THE NEW W. EDWARD BALMER SCHOOL

SCHOOL BUILDING COMMITTEE MEETING

APRIL 2, 2019

A01- ITEM 16

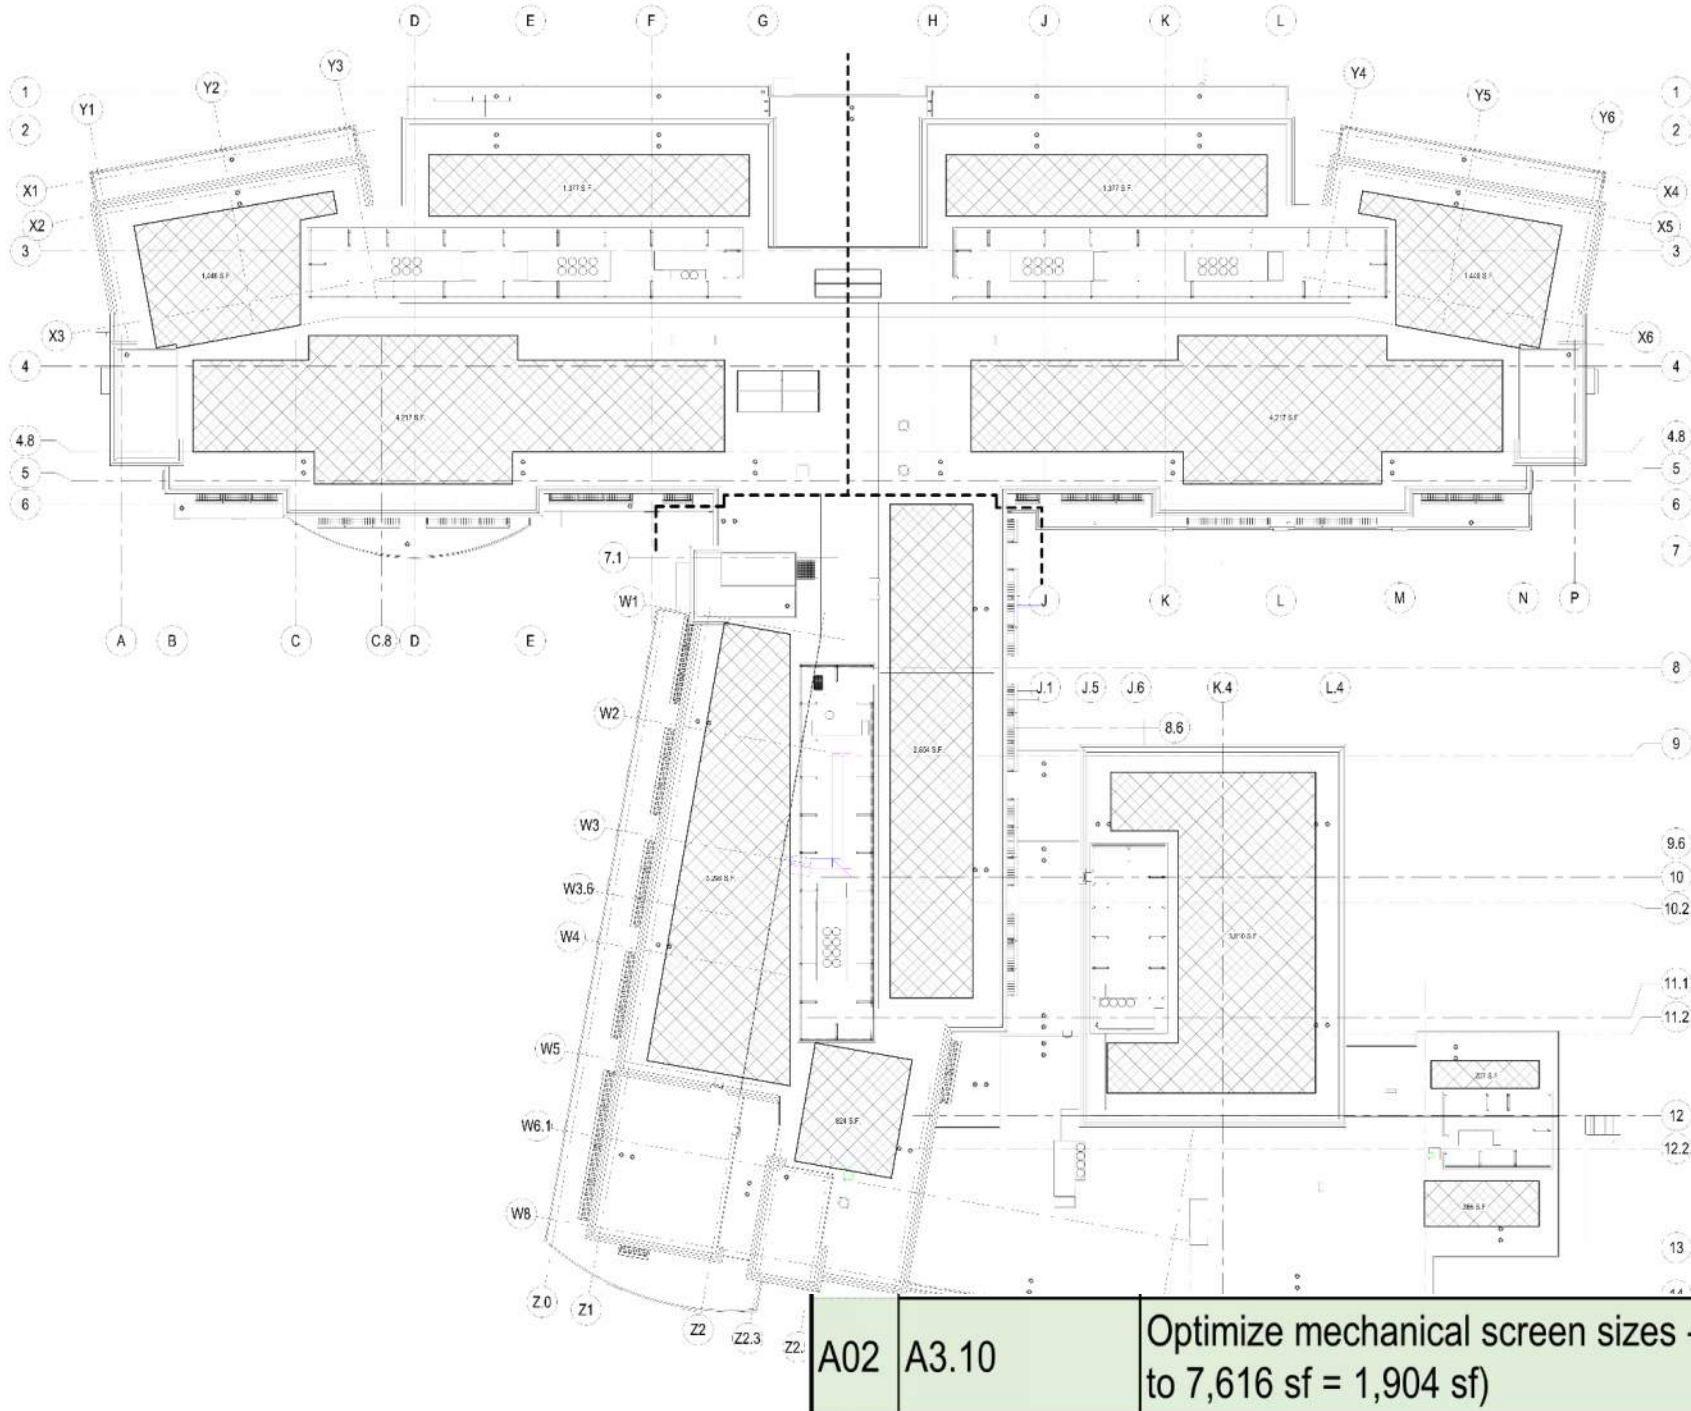
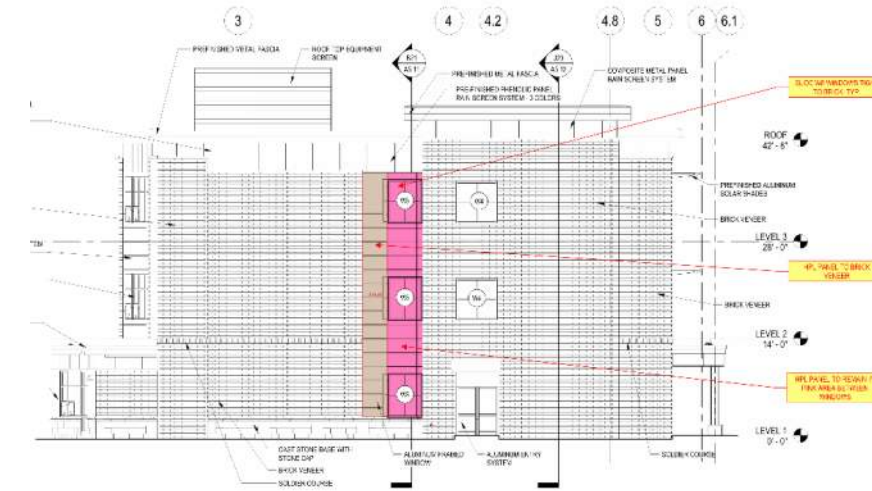
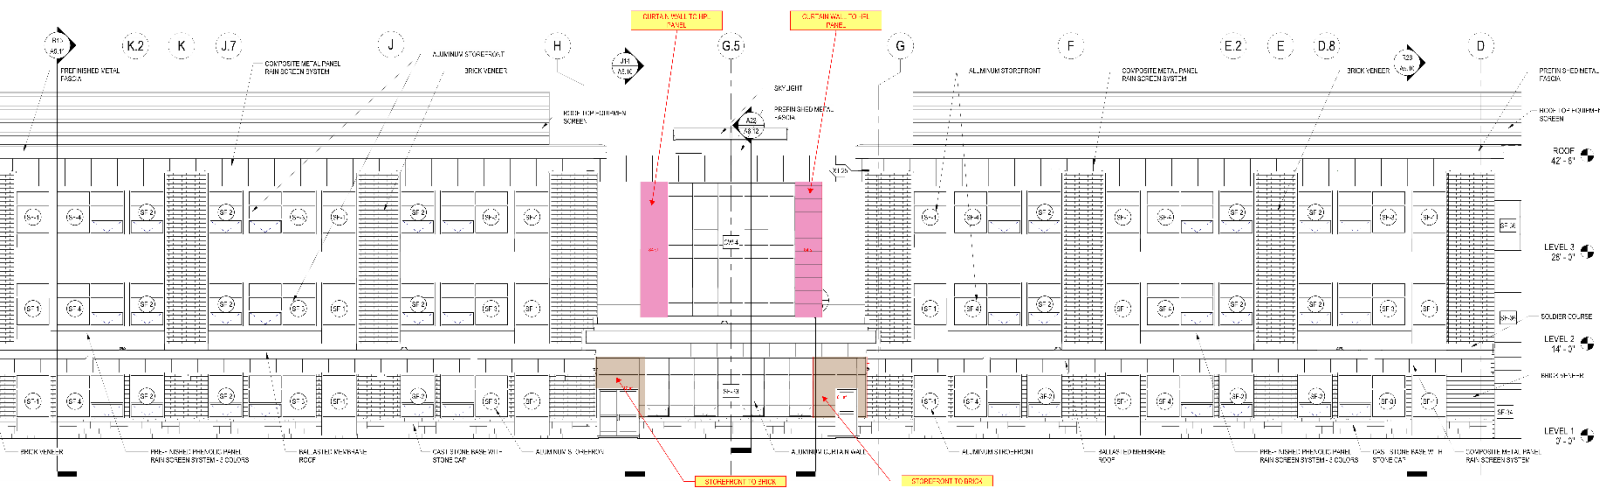
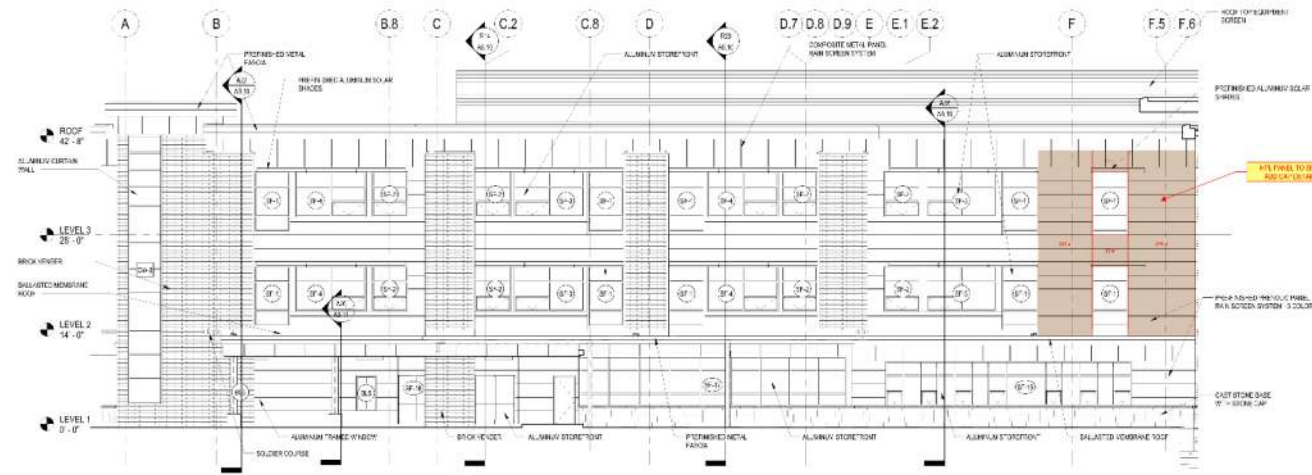
A01	A4 dwgs / Item 16	Provide Utility brick ILO standard Modular brick on entire building.	(\$90,585)
-----	----------------------	--	------------

A03	A4.11-13 / Item 8	Change cladding from HPL Panel to Brick - 1,123 SF - see drawings \$29.84 SF	(\$33,507)
A04	A4.12 / Item 8	Change CW glazing system to HPL Panel system - 168 SF - see drawings \$30.25 SF	(\$5,082)
A05	A4.12 / Item 8	Change SF glazing to Brick cladding - 103 SF - see drawings \$28.25 SF	(\$2,910)

VE LIST: ITEM 18

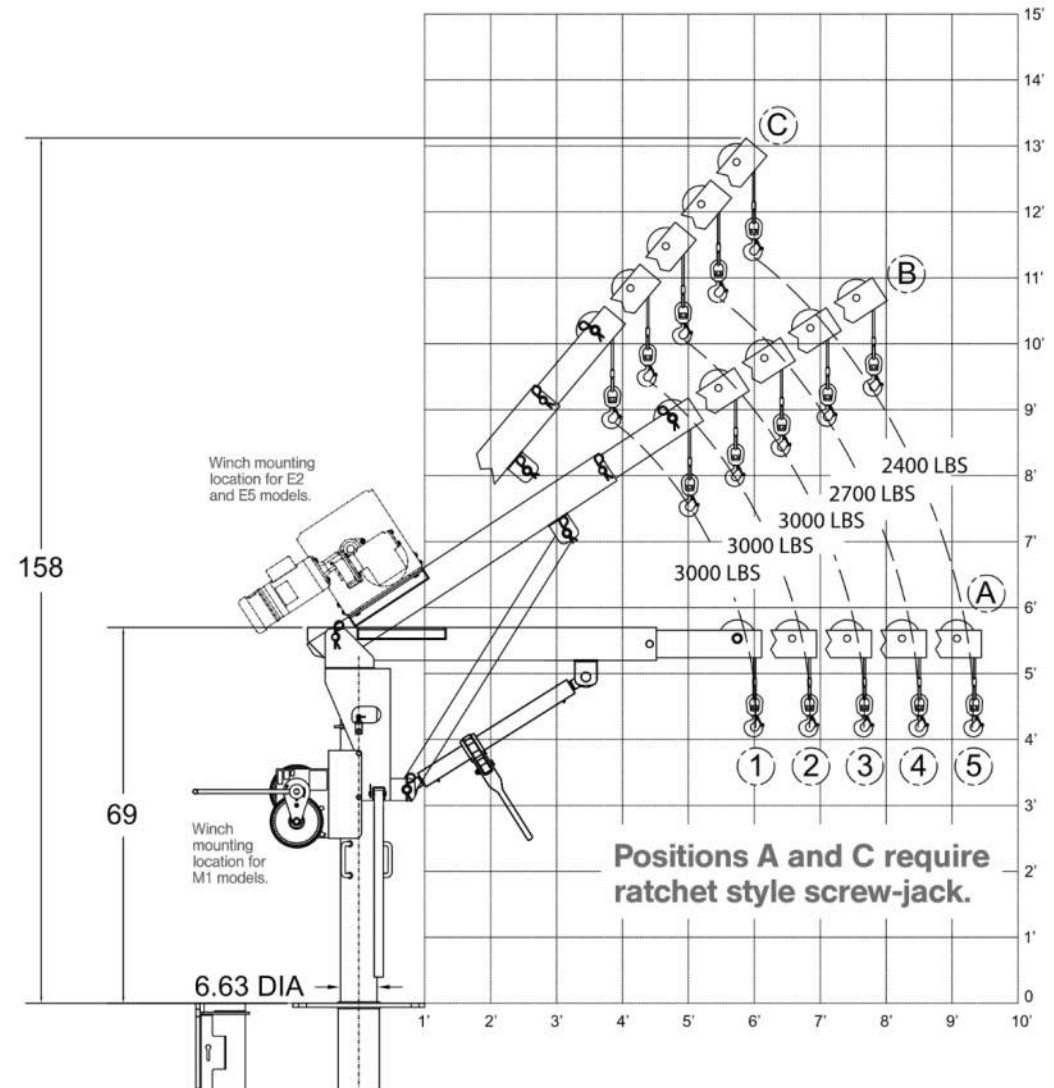
Item 18

ADD Roof Hoist

\$48,200

VE LIST: ITEM 28

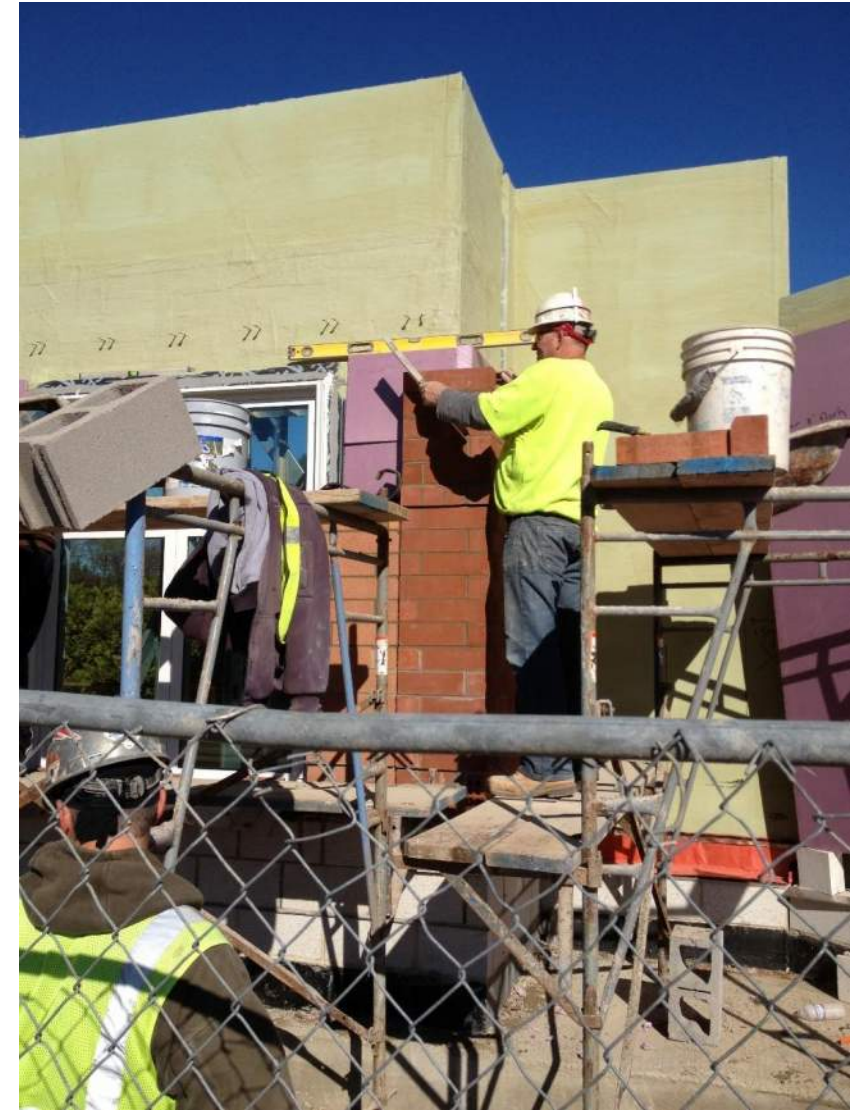
Item 28

Delete specified exterior mock-ups and go with in-place ILO

(\$41,000)
